Item ID: D206-667-207BL

Item Name: Crosstube Mid Aft

DART AEROSPACE LTD HAWKESBURY, ONTARIO, CANADA	
DRAWING NO. D206-667-247	REV. A SHEET 1 OF 4
TITLE CROSSTUBE ASSY (206L MID AFT)	SCALE NTS

DRAWING NO. D206-667-247	TITLE CROSSTUBE ASS'Y (206L MID AFT)	REV. A	DART AEROSPACE LTD ENGINEERING ORDER		D.E.O. NO. D206-667-247-A-1	SHEET NO. SHEET 1 OF 1	SCALE NTS
DRAWN 92	CHECKED ASS	MFG. APPR. KD	APPROVED JMP		DE APPR. H		
DATE 11.07.15	DATE 11.07.20	DATE 11.07.21	DATE 11/07/21		DATE 11.7.21

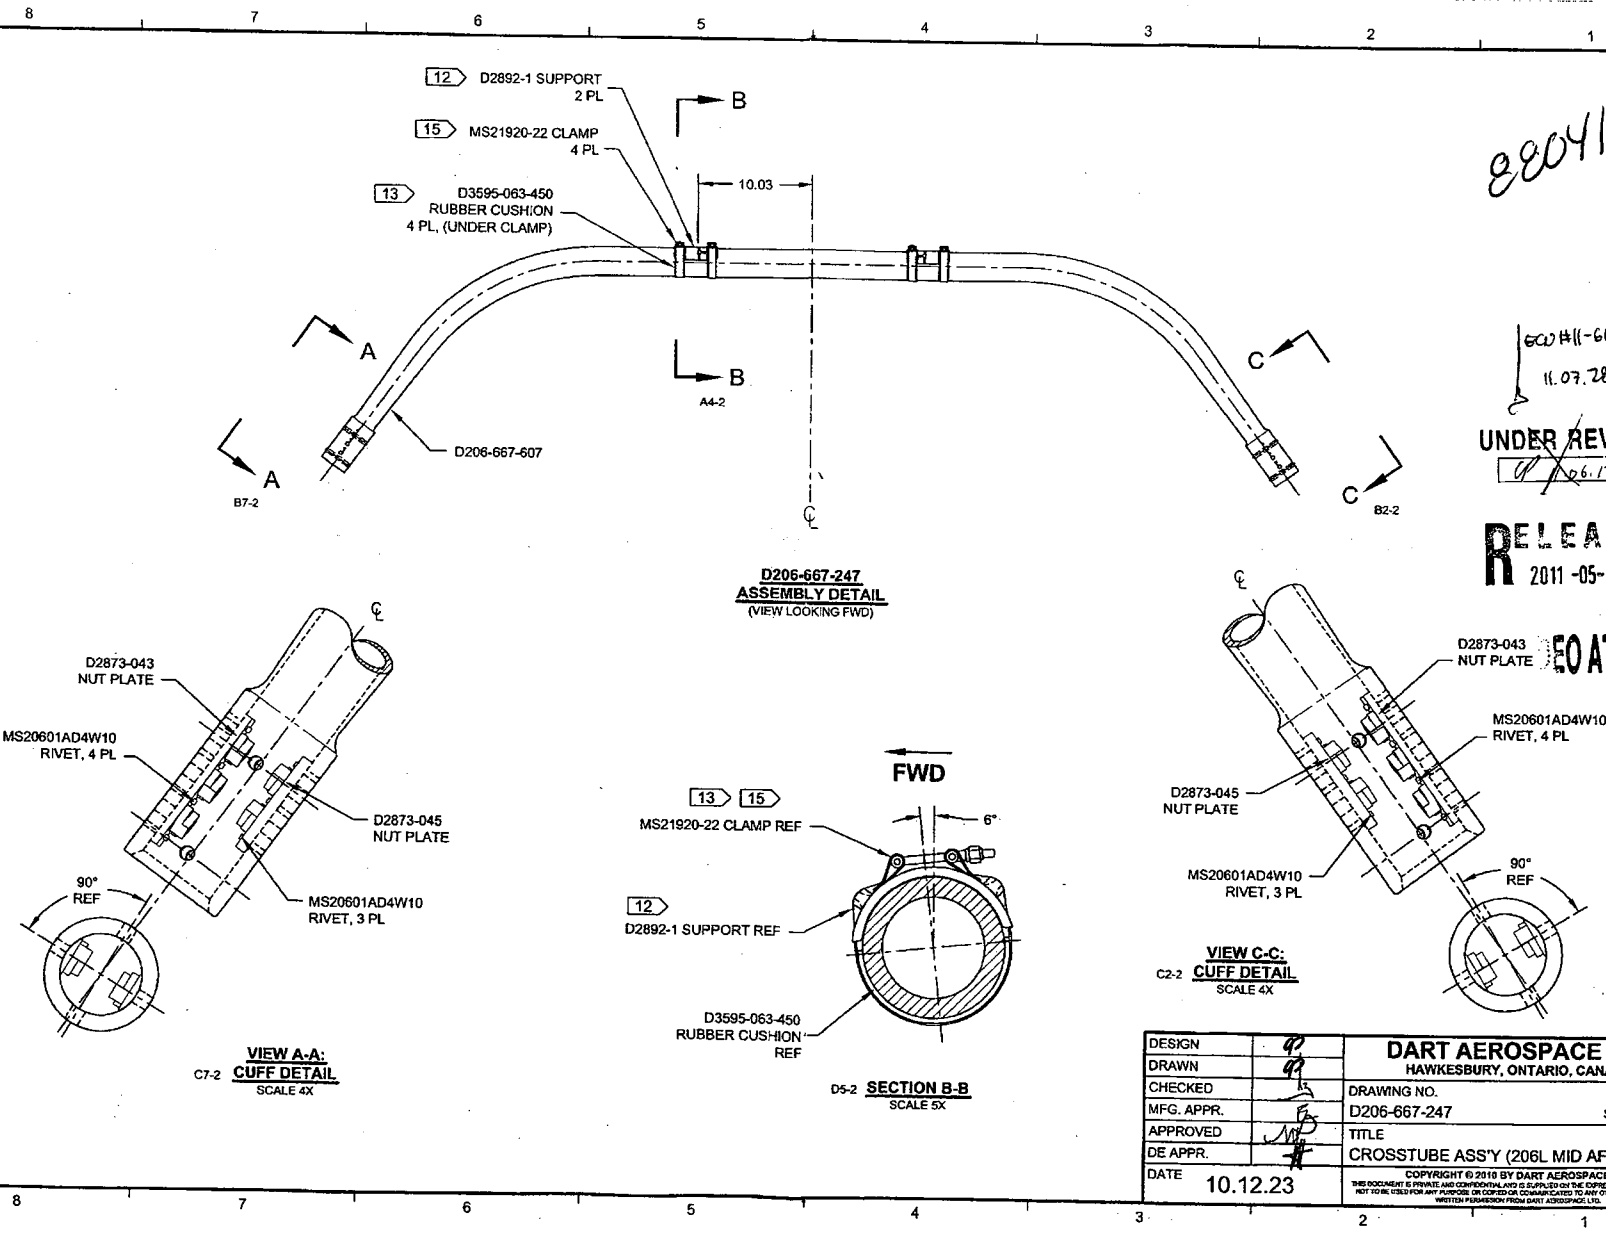
REPLACE MAGNOBOND WITH PROSEAL.

NOTE 12 &amp; 15, SHEET 1 IS AMENDED AS FOLLOWS:

- 12) TO INSTALL D2892-1 SUPPORT: ABRASE MATING SURFACE OF SUPPORT AND CROSSTUBE WITH 180-GRIT SANDPAPER AND REMOVE RESIDUE WITH MEK (OR EQUIVALENT). APPLY A 0.04" TO 0.07" THICK LAYER OF PROSEAL 890 CLASS B-2 (OR AMS-S-8802 CLASS B-2) SEALANT TO MATING SURFACE OF SUPPORT.
- 15) TORQUE CLAMPS 80 TO 100 IN-LB. ENSURE AT LEAST 1.5 THREADS SHOWING IN SAFETY AND THAT NUT HAS NOT BOTTOMED-OUT AFTER TORQUING. **PRIOR TO PACKAGING, RE-CHECK TORQUE ON CLAMPS AFTER PROSEAL 890 SEALANT HAS CURED FOR 72 HOURS.**

**DETAIL L: CROSSTUBE CUFF**  
SCALE 2.5X

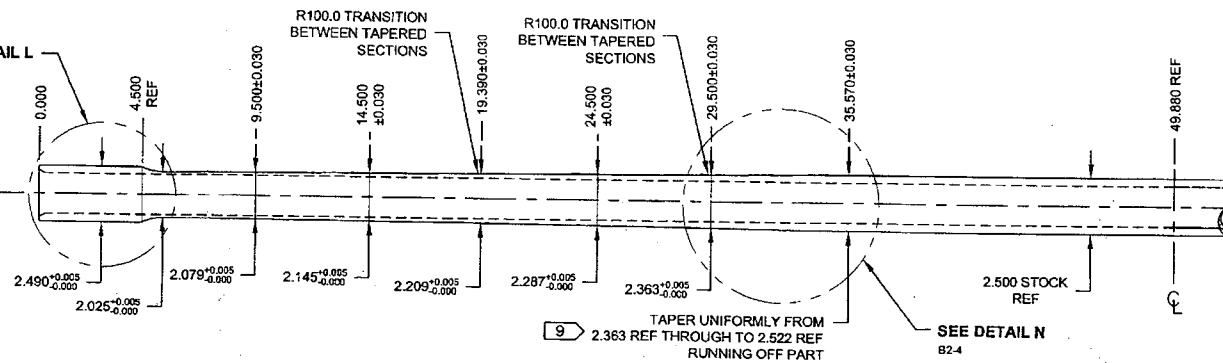
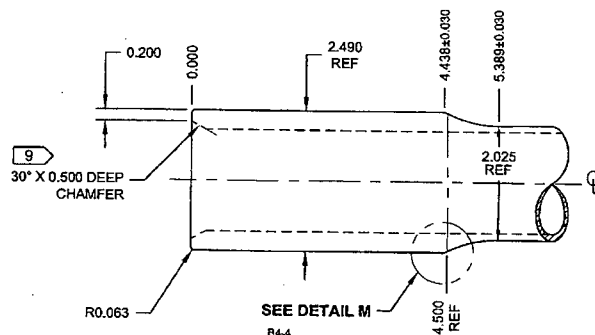
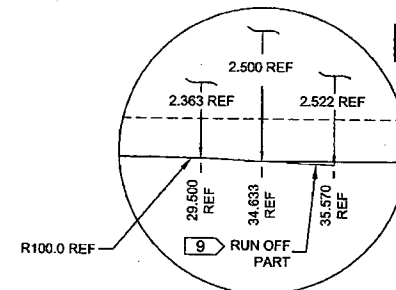
Doc/Data		<i>12/8/24</i>	<i>110</i>	<i>1</i>	<i>crush over to</i>		<i>Acceptable per email</i>		<i>DAS 16 12/08/24</i>	<i>DAS 16 12/08/24</i>	
Equip/Tooling											
Operator											
Material											
Setup											
Other											
Process											
Supplier											
Training											
Unapproved											
<b>FAULT CATEGORY</b>											
<b>Landing Gear</b>			<b>General</b>								
<input type="checkbox"/>	Bending	<input type="checkbox"/>	Bend	<input type="checkbox"/>	Grain	<input type="checkbox"/>	Ovalized	<input type="checkbox"/>	Pressure/Forced		
<input type="checkbox"/>	Centre Not Concentric to O/S	<input type="checkbox"/>	BOM/Route	<input type="checkbox"/>	Hardware	<input type="checkbox"/>	Over/Under tolerance	<input type="checkbox"/>	Temperature/Cure		
<input type="checkbox"/>	Cracks	<input type="checkbox"/>	Broken/Damaged	<input type="checkbox"/>	Inspection Incomplete	<input type="checkbox"/>	Part Incorrect	<input type="checkbox"/>	Weld

Here is another cross tube that has the crushing out of drawing tolerance. D206-667-207 B88855
